ADDENDUM #1

PROJECT: Secure Entry Office Addition and Building/Site updates
at Manor Elementary School
for Monroe Public Schools
#20161

CONSTRUCTION FLOOR PLAN
SCALE: 1/8" = 1'-0"

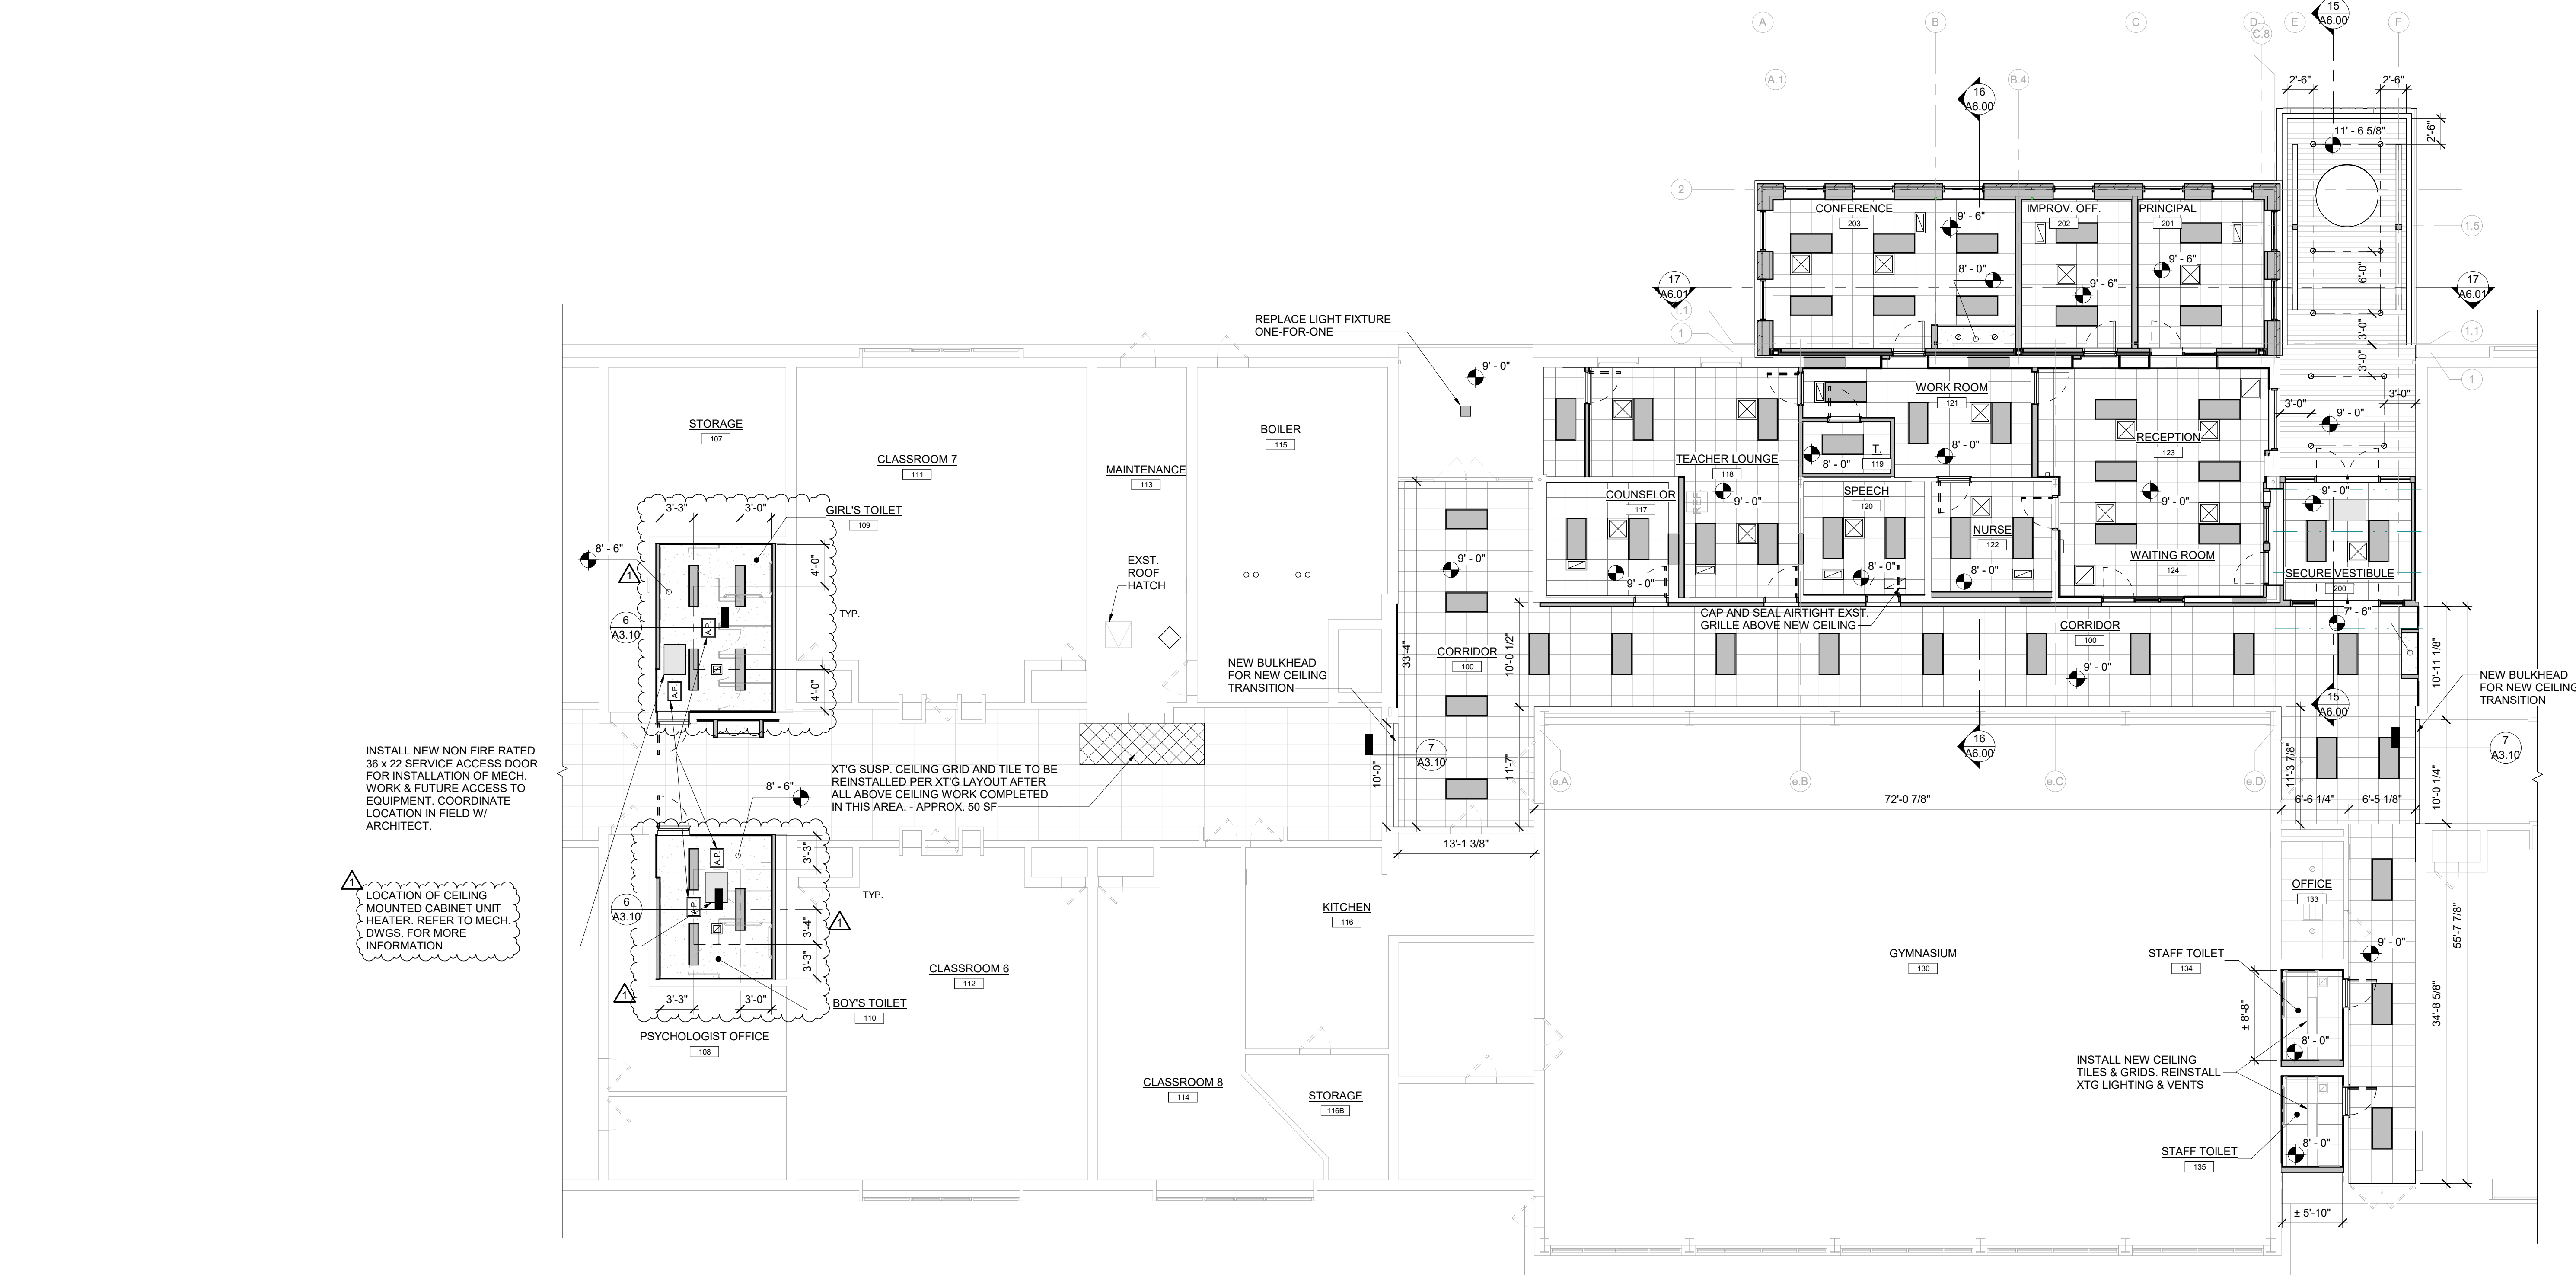
- A. A2.10 – CONSTRUCTION FLOOR PLAN (RE-ISSUED HEREIN)
 - 1. Added Tags “W123a” & “W124c” for coordination with “DOOR SCHEDULE”/A9.00.
 - 2. Exterior Elevation Tag placement has been adjusted for visibility, no changes made to this elevation.
- B. A3.10 – REFLECTED CEILING PLAN (RE-ISSUED HEREIN)
 - 1. West gang toilet rooms lighting layout updated to incorporate new ceiling mounted mechanical units.
 - 2. Notes added to coordinate mechanical work on the ceiling in the West gang toilet rooms.

23
A6.00 **WALL SECTION**
SCALE: 3/4" = 1'-0"

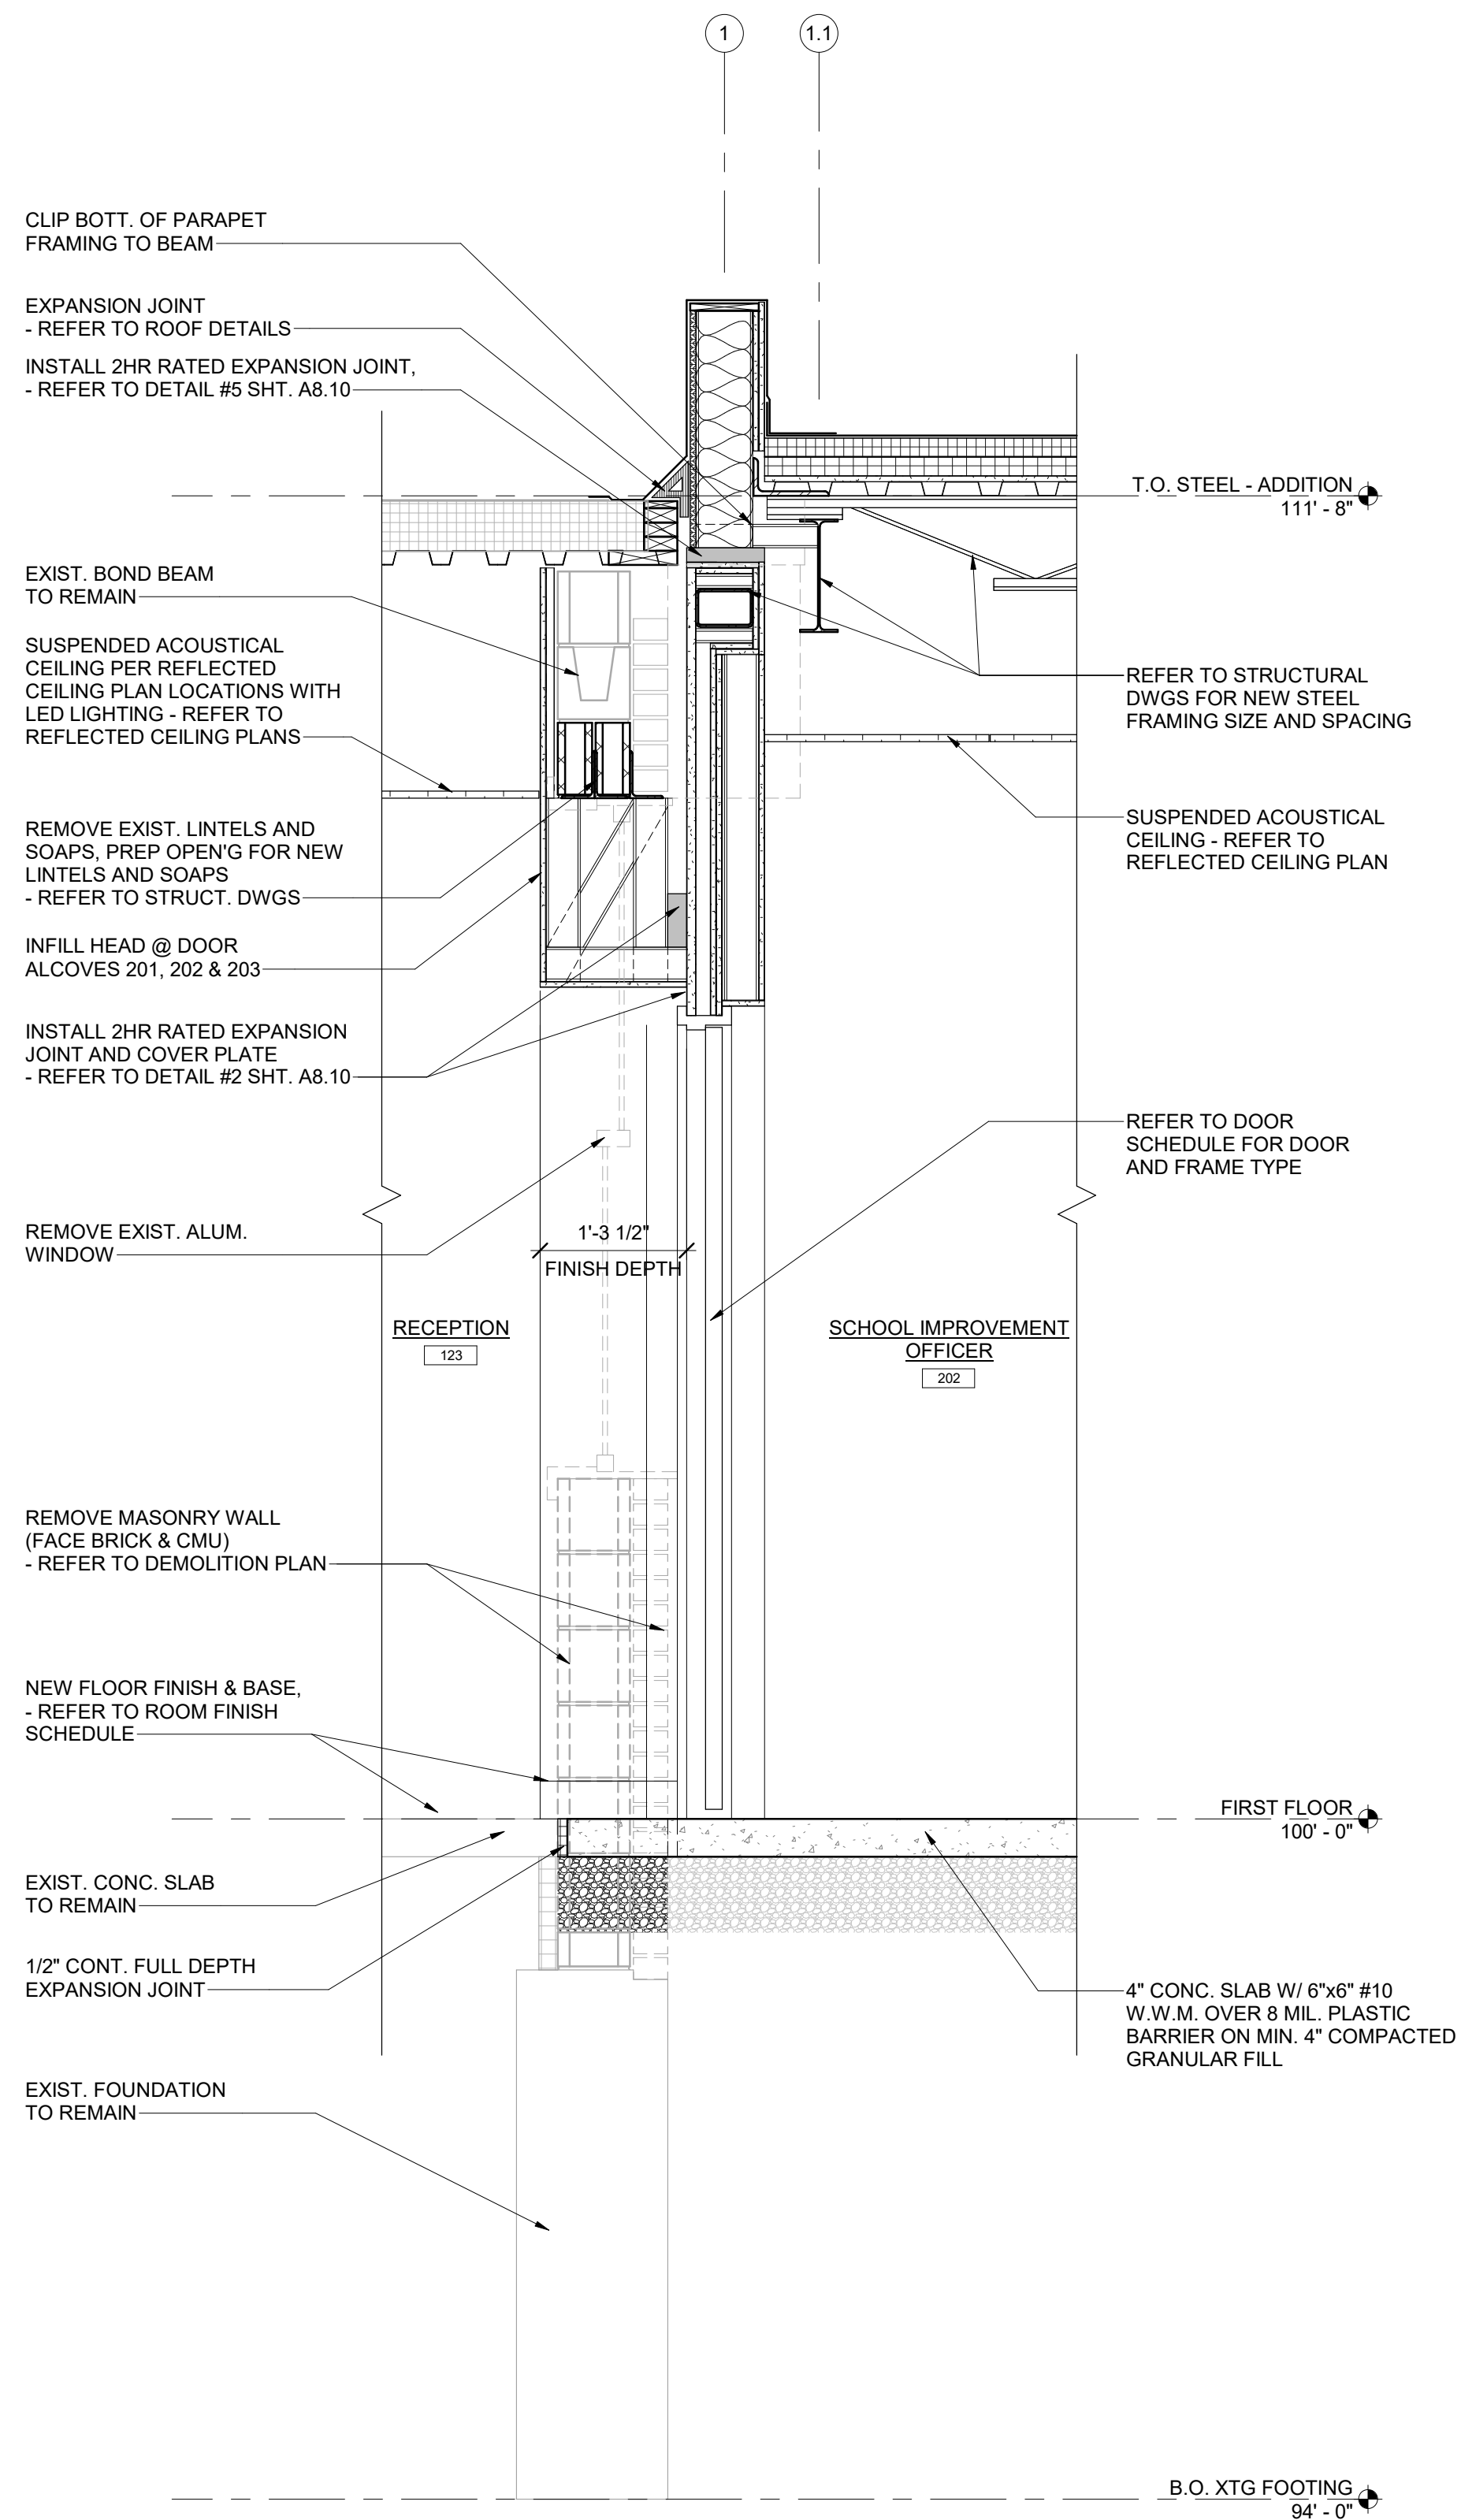
- ii. “AREA “18” MAIN BUILDING ROOF” – SYSTEM”: note updated to remove: *“TEAR OFF TO METAL DECK”*
- D. A6.51 – WALL SECTIONS (RE-ISSUED HEREIN)
 - 1. Wall Section #23/A6.00 was updated to maintain the 1 HR fire wall construction between Vestibule (#200) and Reception (#123).

25 SECURE ENTRY & OFFICE ENLARGED PLAN - NEW
A1.00 SCALE: 1/4" = 1'-0"

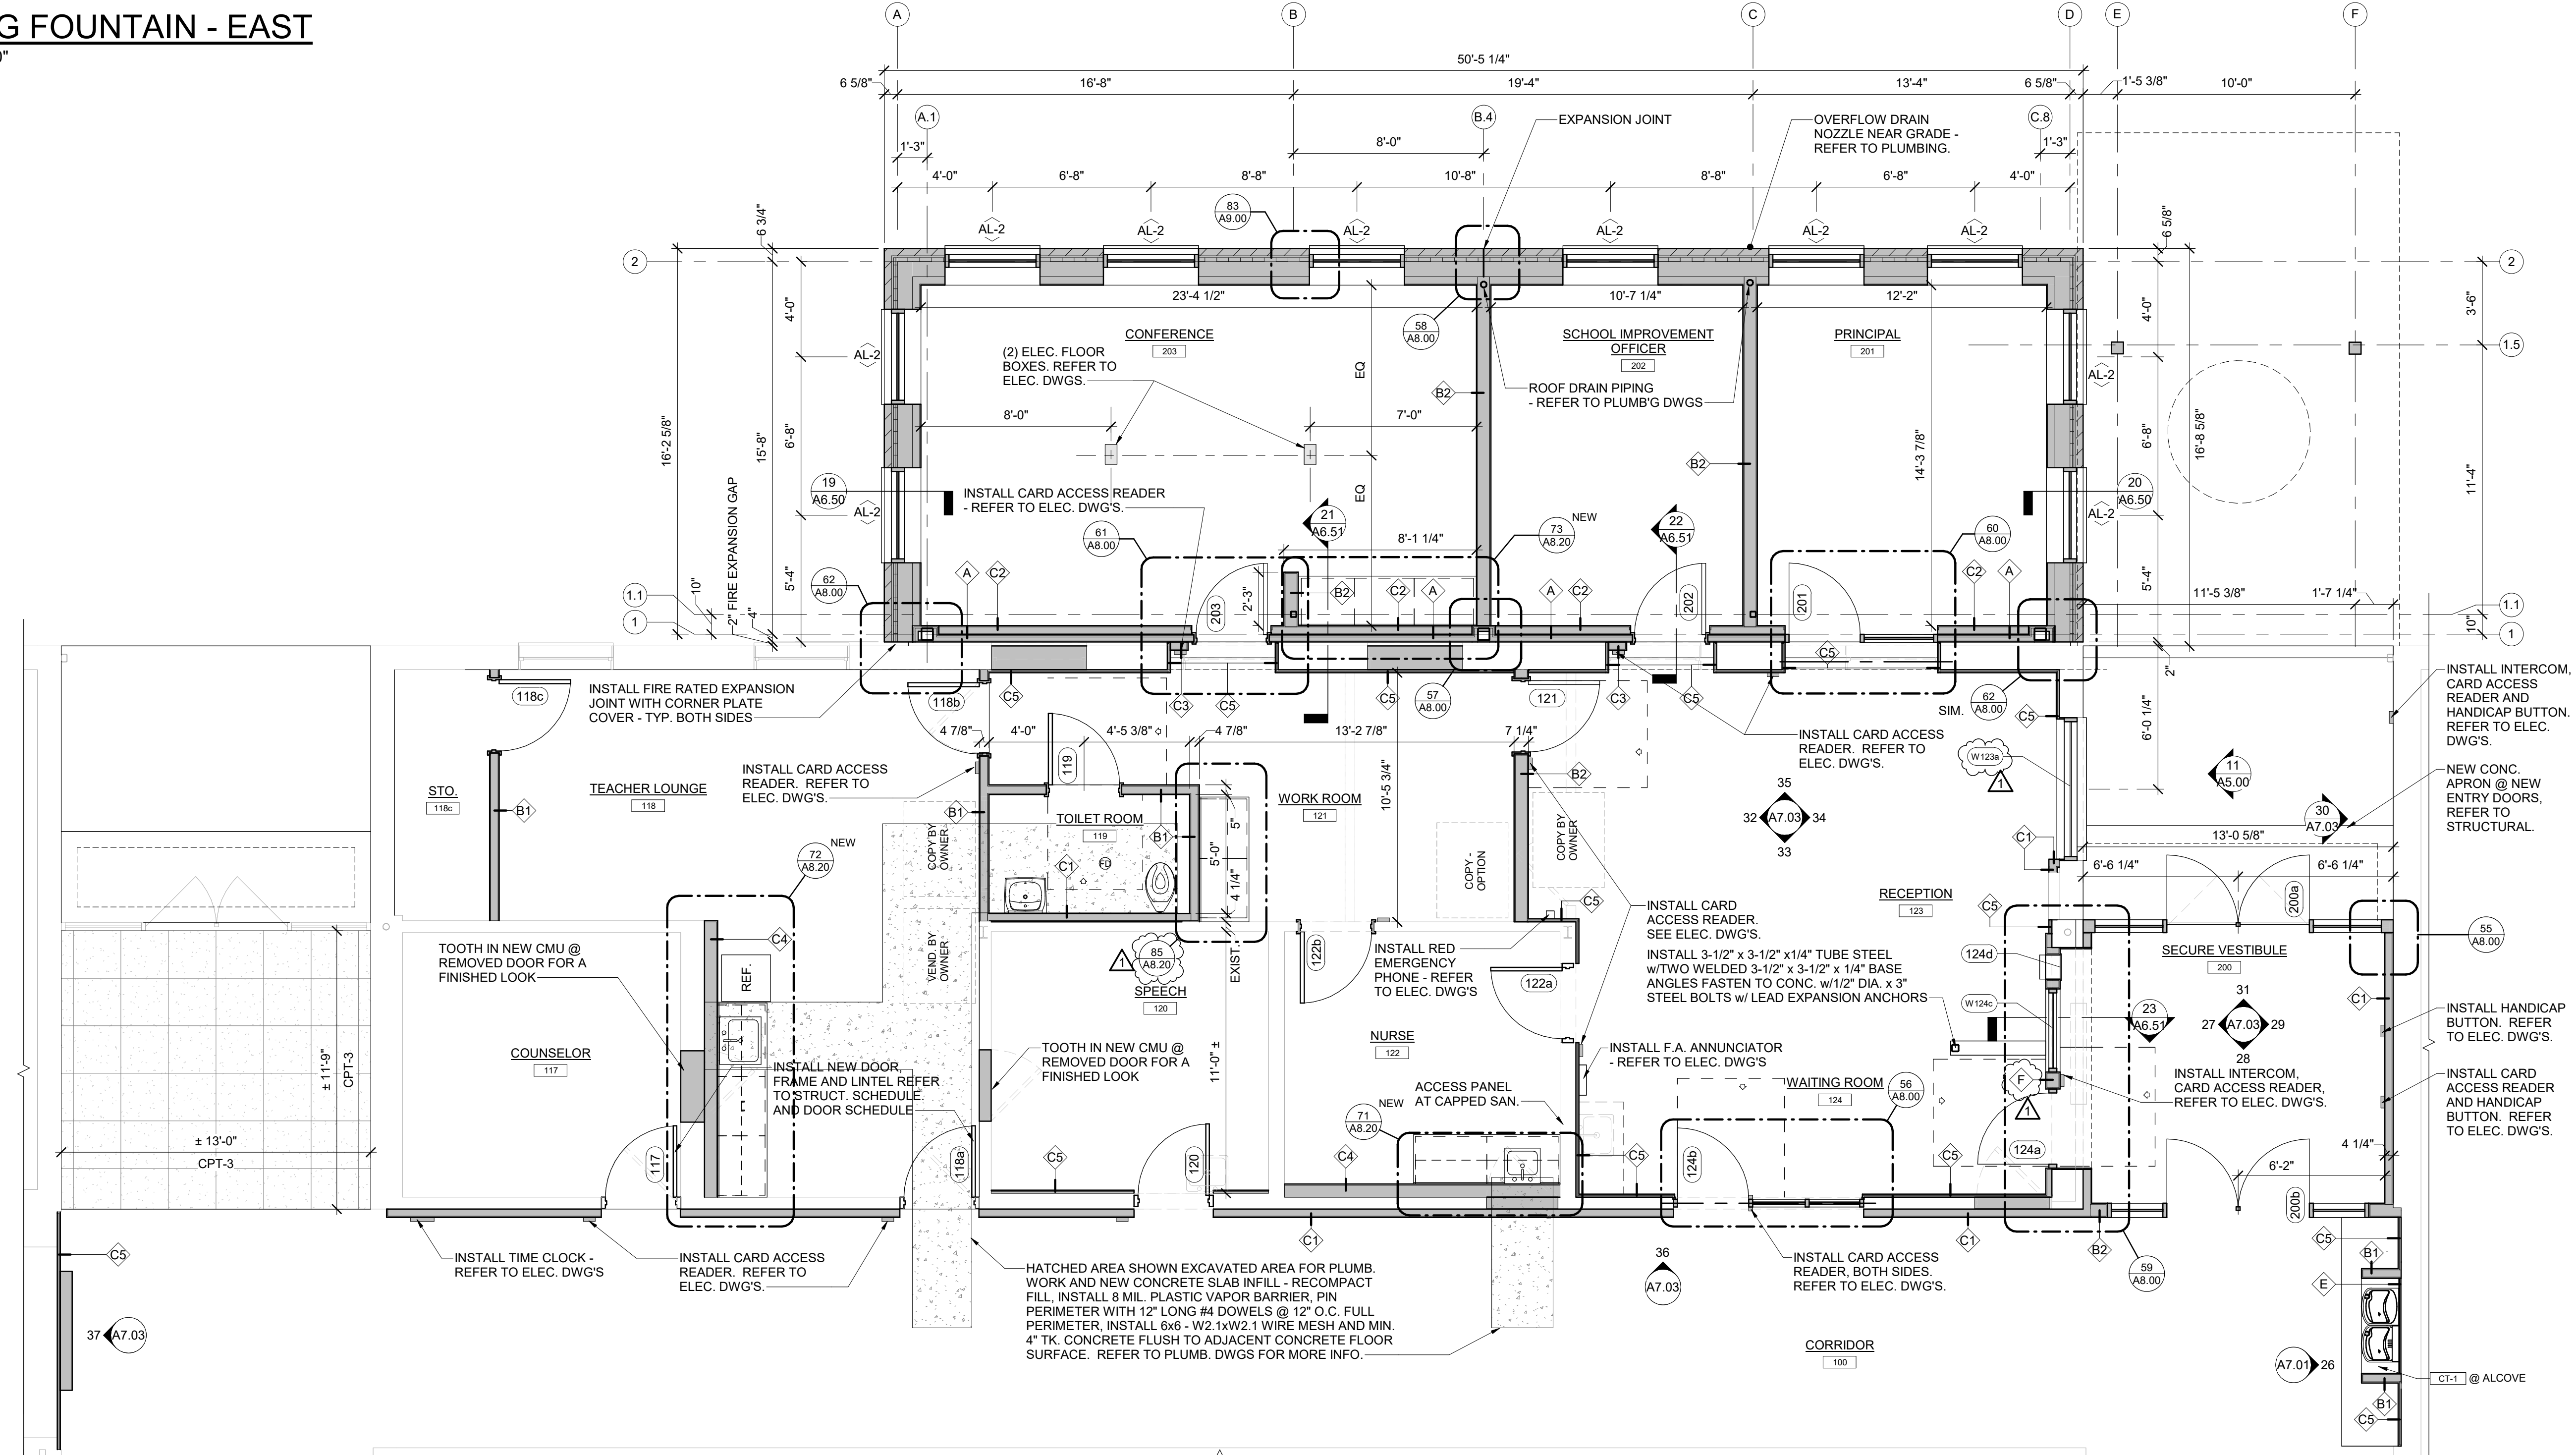
- E. A7.01 – SECURE ENTRY & OFFICE ENLARGED PLAN – NEW (RE-ISSUED HEREIN)
 - 1. Window Frame Tag “W123a” added to coordinate with “DOOR SCHEDULE”/A9.00.

- 2. Wall Tag “F” added to wall between Waiting Room (#124) and Vestibule (#200).
 - 3. “WALL LEGEND” updated.
- F. A7.05 – WEST TOILET ROOMS – PLANS (RE-ISSUED HEREIN)
